# **Dolby Laboratories Inc**

Field Bulletin No. 149 - May 1986

## **MODIFICATIONS TO DOLBY MAGNETIC PRE-AMP UNIT (MPU)**

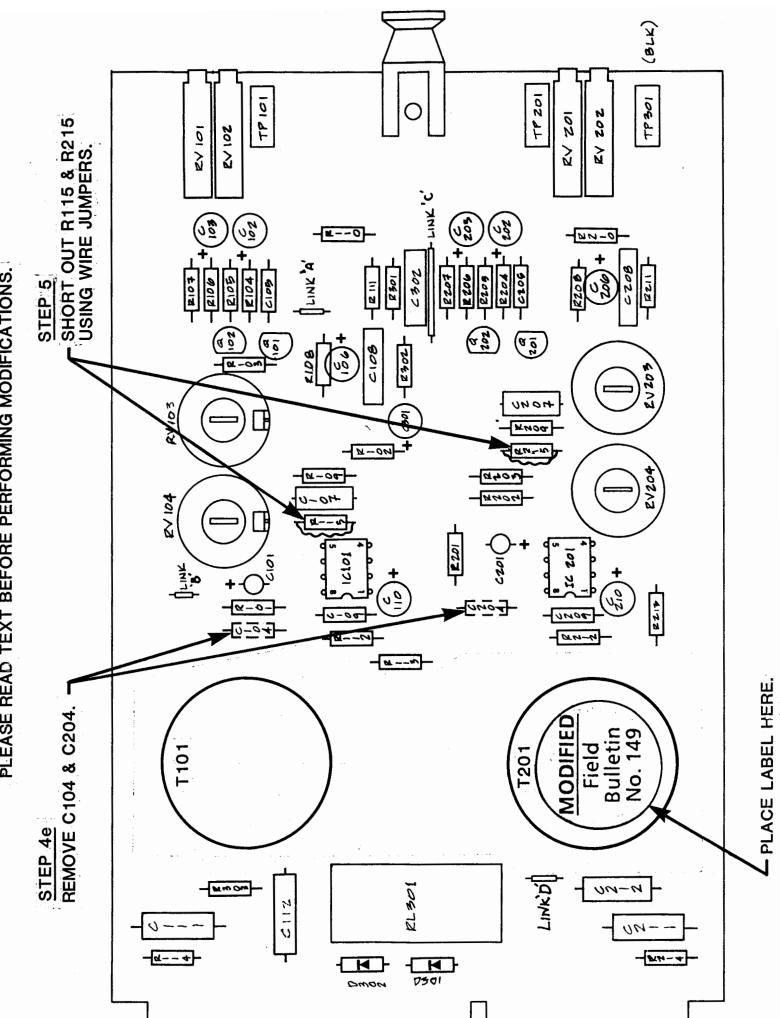
e. Remove Cat 92-4 from extender card.Locate and remove capacitors C-104 and C-204 (see Fig. 1).

- 5. ONLY if there is still a slight peaked response at 12 kHz, solder a shorting strap onto the pre-amplifier as shown in Figure 1. If you have this problem on the first channel you examine, you will probably have to add the shorting strap to all the other channels as well.
- 6. Run Dolby level test film. Adjust gain controls for Dolby level.
- **Completion:** When all modifications are completed, place a modification sticker on the top of the transformer on each circuit board.

Remove capacitors C-104 and C-204 from the remaining 70mm Cat. No. 92-4's. Adjust each channel for flat freqency response. Each channel should yield a similar response.
